Proposal for Supplement 1 to the 05 series of amendments to Regulation No. 48 (installation of lighting and light-signalling devices)

To simplify and clarify requirements for the headlamps initial aiming, aiming tolerances and making it independent from the light source used in the headlamp.

The text reproduced below was prepared by the expert from Poland to amend requirements in Regulation No. 48 to take into consideration real visibility distance and glaring according to headlamps Regulations.

The above limits and the initial aiming values are summarized in the diagram below.

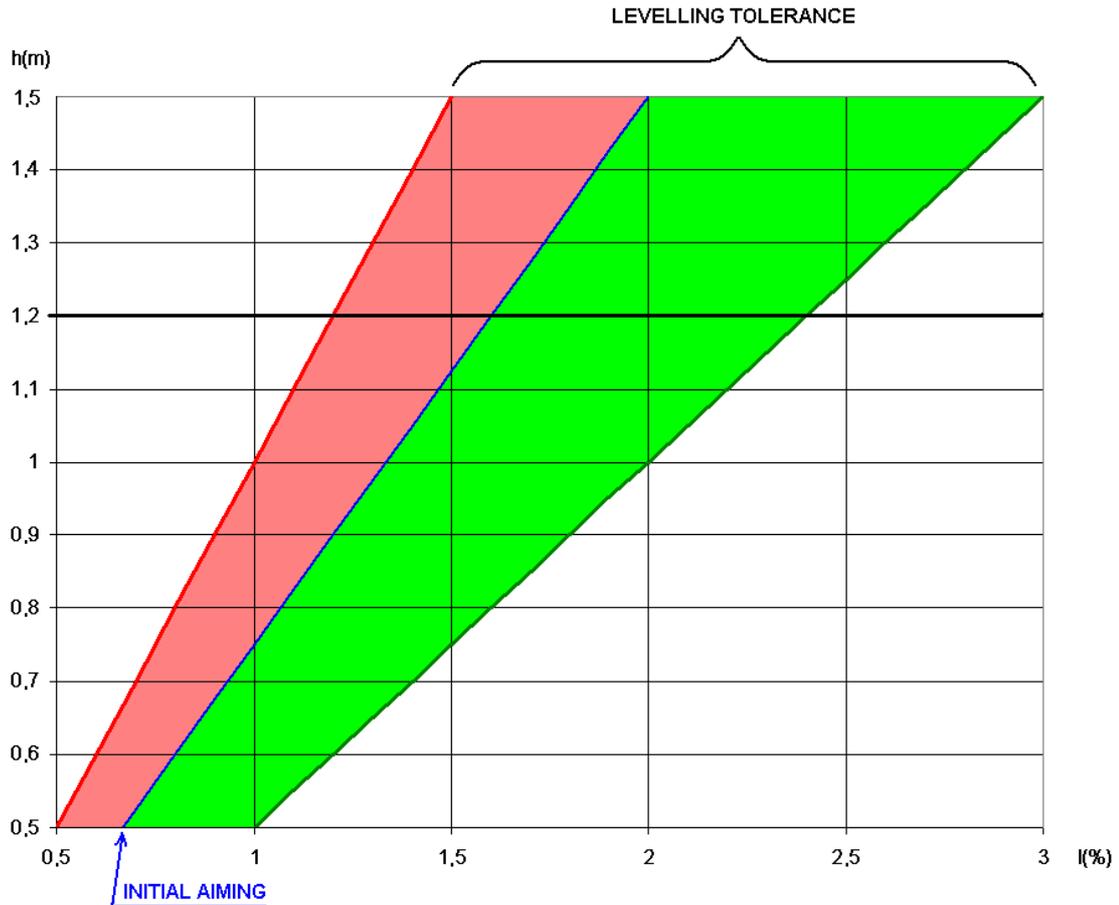
"6.2.6.1.2. Depending on the mounting height in metres (h) of the **dipped-beam headlamp reference axis the vertical inclination of the cut-off of the dipped beam, (in the direction of the reference axis) measured on the unladen vehicles, taking in account 0.1 per cent accuracy, shall have the value of initial aiming for which the horizontal part of cut-off crosses the surface of flat horizontal road at the distance of 75 m from the headlamp.**

The aiming limits under all the static conditions of Annex 5 should be such that the distance of crossing of vertical part of cut-off with road surface shall remain between [50m] and [100m].

limits: ~~between 0.5 per cent and 2.5 per cent~~
initial aiming: ~~between 1.0 per cent and 1.5 per cent~~

limits: ~~between 0.5 per cent and 2.5 per cent~~
initial aiming: ~~between 1.0 per cent and 1.5 per cent~~

limits: ~~between 1.0 per cent and 3.0 per cent~~
initial aiming: ~~between 1.5 per cent and 2.0 per cent~~

limits: ~~between 1.0 per cent and 3.0 per cent~~
initial aiming: ~~between 1.5 per cent and 2.0 per cent~~
